NW-12 Vault

Thursday, July 24, 2025 3:03 PM

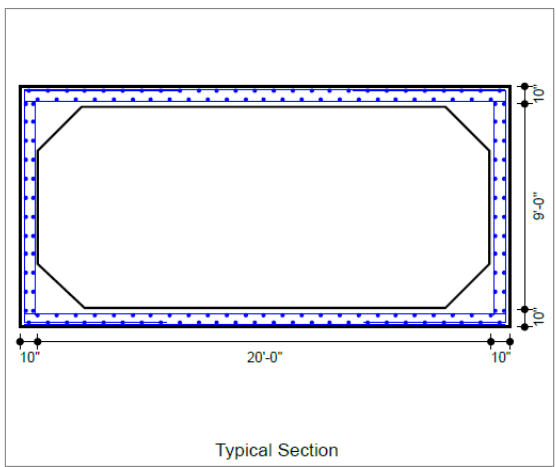
- Verified top and bottom steel in the top slab and the walls
 - Chipped out and identified
 - Requested photos
 - 60 ksi on rebar was written in field
 - Core test on concrete

- 6500 psi
- Mohammad S. - not sure why we would allow them to test the concrete and use that strength (concrete gets stronger over time)
- Mohamad A. - not concerned with the concrete strength - concerned with the jacks - takes back the comment - cannot use one sample for the entire vault (300')
 - Can buy 3-4 ksi concrete
- Modelling middle pole brace as a 6" thick wall
- Design the middle wall
 - Then backing it out to get the post size
- Posts
 - Only taking live load and dead load from the pavement
 - Mohamad A. - he can buy that - dead load of the structure is already at the sides
 - Takes no issue with that
 - Concern goes back to the posts
